FREDERICK COUNTY PLANNING COMMISSION

TITLE: Tolley Terrace, Section 5, Lots 501-504R,
and Section 6, Lots 601-603R

FILE NUMBER: S-734, AP 13392 (APFO 13394, FRO
13395)

REQUEST: Preliminary Plan Approval

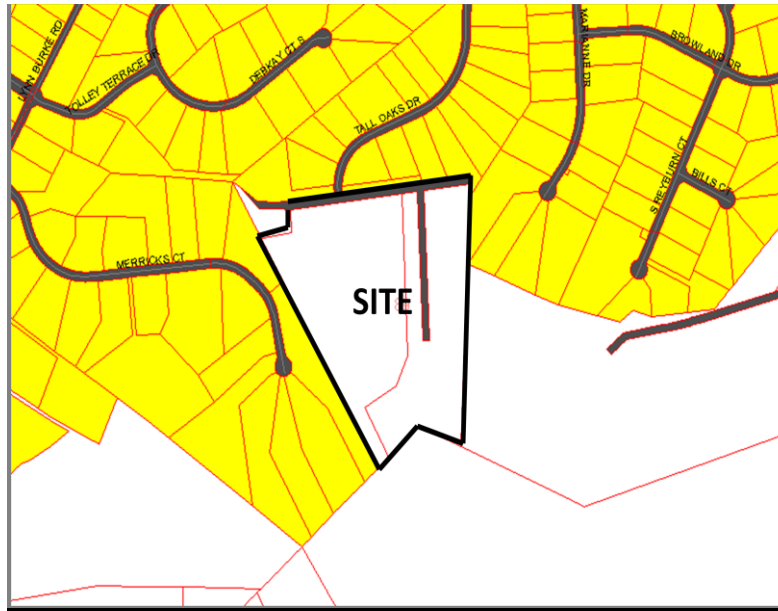
The proposed lots range in size from 1.81 acres to 14.20 acres and therefore meet the minimum 40,000 sq. ft. lot size requirement.

The proposed lots will meet the minimum lot width (100 feet) and yard area (40 foot front yard, 30 foot rear yard, and 10 foot side yard) requirements for single family dwellings in accordance with §1-19-6.100 of the Zoning Ordinance. Two minor drafting errors on the plat must be corrected. The 30 foot yard area shown on Lot 601 must be increased to 40 foot front yard area, and a portion of the 40 foot yard on Lots 501 and 502 cross into the dedicated right of way. These issues are noted in the Hansen comments and is covered under the “comply with all Staff and agency comments” condition on page 8 of this report.
